# Access Compliance Report

## Public Rights-of-Way

### (Curb Ramps)

Intersection ID: 12998	Main Street: 5TH_ST	Cross Street: MCDOWELL_ST	Location: E
ADA ID: FC2D119BF4E0	Ramp Type: Perp	Initial Pass/Fail: Fail	Overall Compliance: No
Severity Score: 12.5			
Codes/Mitigation Info/Possible Solution		Field Measurements/Component Compliance

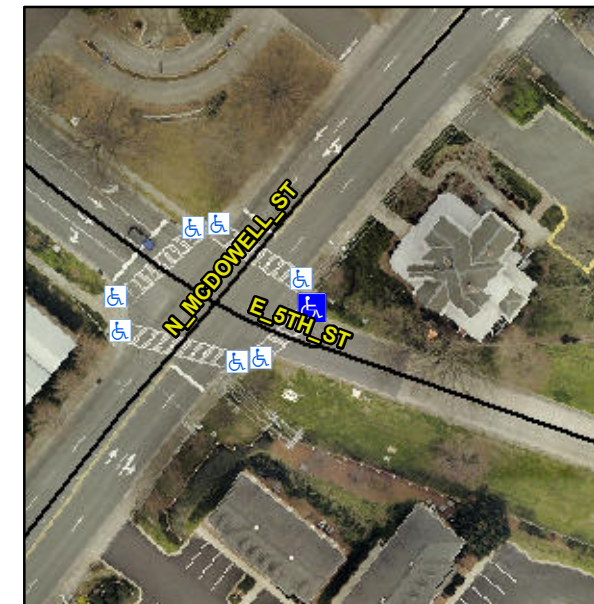
**Not Found, R304.5.3**

Compliance	Description	Data	Compliance	Description	Data
N/A	Ramp Length (in)	72.0	Yes	Ramp Slope (%)	6.4
Yes	Ramp Width (in)	54.0	No	Ramp XSlope (%)	6.0
N/A	Flare Type LT	N/A	N/A	Flare Type RT	N/A
N/A	Flare Slope LT (%)	N/A	N/A	Flare Slope RT (%)	N/A
N/A	Flare Traversable LT?	N/A	N/A	Flare Traversable RT?	N/A
N/A	Landing Length (in)	N/A	N/A	DWS Provided?	N/A
N/A	Landing Width (in)	N/A	N/A	DWS Contrast?	N/A
N/A	Landing Slope (%)	N/A	N/A	DWS Length (in)	N/A
N/A	Landing X Slope (%)	N/A	N/A	DWS Full Width?	N/A
N/A	Landing Curb? (Y/N)	N/A	N/A	DWS Offset (in)	N/A
N/A	Shared Landing?	N/A			
N/A	Gutter Ponding?	N/A	N/A	Gutter Slope (%)	N/A
N/A	Gutter Lip Ht (in)	N/A	N/A	Gutter X Slope (%)	N/A
N/A	Painted X Walk1?	Yes	N/A	Painted X Walk2?	N/A
	X Walk 1 Direction	To SW		X Walk 2 Direction	N/A
N/A	X Walk 1 Width (in)	108.0	N/A	X Walk 2 Width (in)	N/A
	X Walk 1 Slope (%)	1.4		X Walk 2 Slope (%)	N/A
	X Walk 1 X Slope (%)	2.5		X Walk 2 X Slope (%)	N/A

**Remove & Replace Entire Ramp.**
